Access Compliance Report

Public Rights-of-Way

Intersection ID: 50193	Main Street: CHARNDON_VILLAGE_CT	Cross Street: BOYCE_RD	Location: NE
ADA ID: D36710D0EEB6	Ramp Type: Directional1	Initial Pass/Fail: Fail	Overall Compliance: No
Codes/Mitigation Info/Possible Solution		Field Measurements/Component Compliance	
Severity Score: 1.25

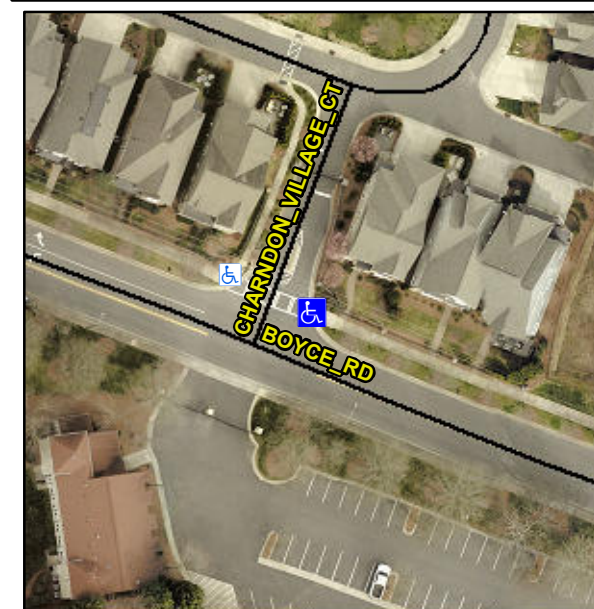
R304.5.3

Compliance	Description	Data	Compliance	Description	Data
N/A	Ramp Length (in)	105.0	N/A	Grade Break?	N/A
Yes	Ramp Width (in)	72.0	N/A	Grade Break Slope (%)	0.0
Yes	Ramp Slope (%)	0.8	N/A	Grade Break XSlope (%)	0.0
No	Ramp XSlope (%)	3.0			
N/A	Flare Type LT	N/A	N/A	Flare Type RT	N/A
N/A	Flare Slope LT (%)	N/A	N/A	Flare Slope RT (%)	0.0
N/A	Flare Traversable LT?	N/A	N/A	Flare Traversable RT?	N/A
N/A	Landing Length (in)	0.0	N/A	DWS Provided?	N/A
N/A	Landing Width (in)	0.0	N/A	DWS Contrast?	N/A
N/A	Landing Slope (%)	0.0	N/A	DWS Length (in)	N/A
N/A	Landing X Slope (%)	0.0	N/A	DWS Full Width?	N/A
N/A	Landing Curb? (Y/N)	N/A	N/A	DWS Offset LT (in)	N/A
N/A	Shared Landing?	N/A	N/A	DWS Offset RT (in)	N/A
N/A	Gutter Ponding?	0.0	N/A	Gutter Slope (%)	N/A
N/A	Gutter Lip Ht (in)	0.0	N/A	Gutter X Slope (%)	N/A
N/A	Painted X Walk1?	Yes		Road Slope (%)	3.3
	X Walk 1 Direction	To W		Road X Slope (%)	1.7
	X Walk 1 Width (in)	88.0		Clear Space?	N/A

Remove & Replace Entire Ramp.
